HOWARD COUNTY HISTORIC PRESERVATION COMMISSION

Agenda

Thursday, July 11, 2019; 7:00 p.m.

Figure 10 - View of 30-inch dbh oak tree to be removed. The tree was damaged when the neighboring tree fell.

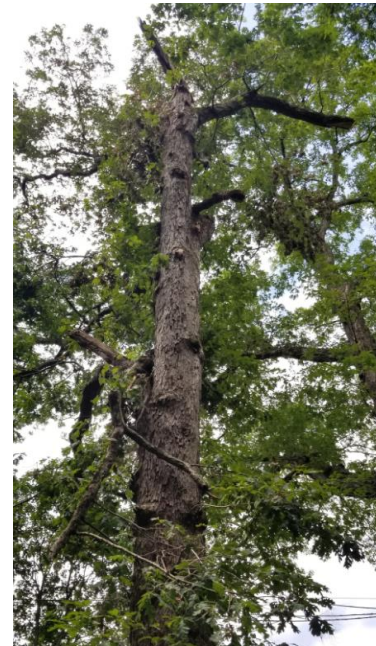
The application explains that the 30-inch oak tree, shown in Figure 10, was significantly damaged when the oak tree fell along College Avenue. The photos show that many of the limbs were sheared off the tree when it fell.

Staff Recommendation to the HPC: Staff recommends the HPC approve the removal of Item 2, the 30-inch damaged oak, and the removal of Items 3a, 3b and 3c the three black cherries along Ross Road (two 16-inch dbh and one 18-inch dbh).

Figure 17 - Window seen from the interior

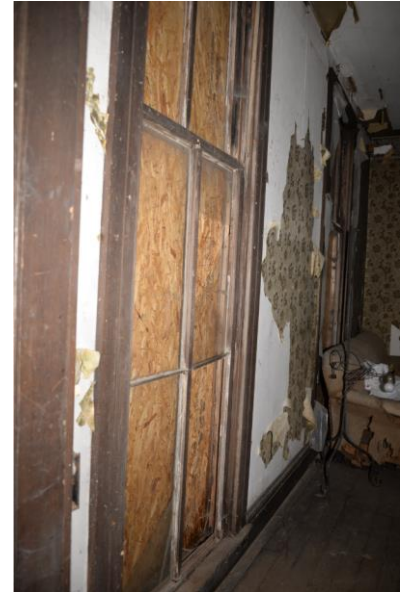
Windows – It is unknown how many windows are on the structure and if any of them can be repaired, versus needing to be replaced. The paint is worn from the windows, so prior to being boarded up, they were exposed to the elements without the protection of paint. The windows should be pictorially documented and inventoried, with the specific replacement noted for each window. Most of the windows appear to be 2:2 as shown from the historic photos and current interior photos, but there are some unique windows such as the round arched windows in the attic. One window visible on the rear of the main structure is a 9:6 with missing shutters (the hinges appear to be on the frames still). The windows are all wood, are quite large and not a standard size (on the main structure), so any replacement windows will need to be custom made. There is a rear ell with windows of a different pattern and size than on the main house. Any replacement should replicate the material, dimensions of profile of the current window muntins, frames and related details, but the existing details need to be documented first. The wood window frames are deteriorating and need to be repaired and/or replaced. The in-kind repair or replacement of windows and frames would qualify for both tax credit programs. The additional information needed on existing conditions can be submitted as the applicant obtains the information, or at the time of the final tax credit claim.

Figure 33 - Proposed sidewalk replacement

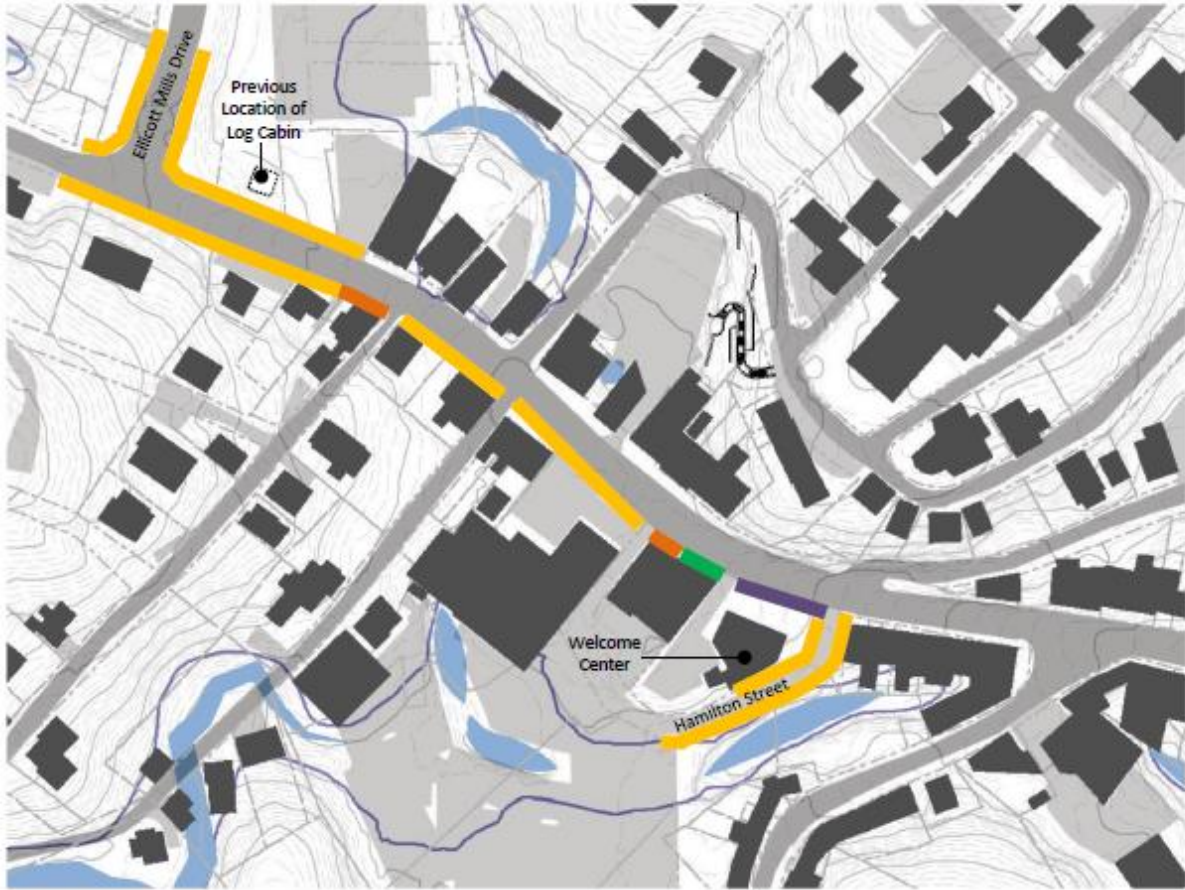
At the Visitor Center (8267 Main Street) location, the application contains drawings with two possible options. The applicant’s preferred option is to use a London Paver scoring pattern in front of the Welcome Center, but shows an alternate option using the single score line if uniformity with the Main Street sidewalks is desired.

The single lateral scoring pattern and its various options will be used in different areas, depending on the existing conditions (width of sidewalk and existing material), as shown on the map in Figure 15 below. In areas where the sidewalks are currently concrete, a 12 to 18-inch band of existing concrete will remain at the building face, with a joint between the new and existing concrete. The application explains that this will minimize disturbance adjacent to the building and allow for future repairs without having to impact the pavement immediately adjacent to the building. For areas of sidewalk installation that are currently asphalt, a new concrete joint is proposed at 12 to 18-inches from the building façade to allow for the clean replacement of a panel in the future for maintenance work without creating an impact to the pavement immediately adjacent to the building. Both scenarios will contain the same 12 to 18-inch joint to match.

While the proposed scored concrete sidewalks do not comply with the Guideline recommendations to replace the sidewalks with brick, the existing adopted design guidelines do not anticipate flood resilient materials and scenarios or account for high velocity floods and the corresponding shear stress on the infrastructure.

The proposed concrete sidewalks would comply with the goal of Chapter 10.A in that it would involve the uniform use of one material and would “create an identifiable, attractive historic commercial area.” Some of the areas to be replaced are existing concrete sidewalks, which would be an in-kind replacement. By extending the use of concrete to other areas, it will help to maintain uniformity and a cohesive streetscape.

Staff Recommendation to the HPC: Staff recommends the HPC determine if the proposal meets the intent of the Guidelines and make an approval based on that determination.
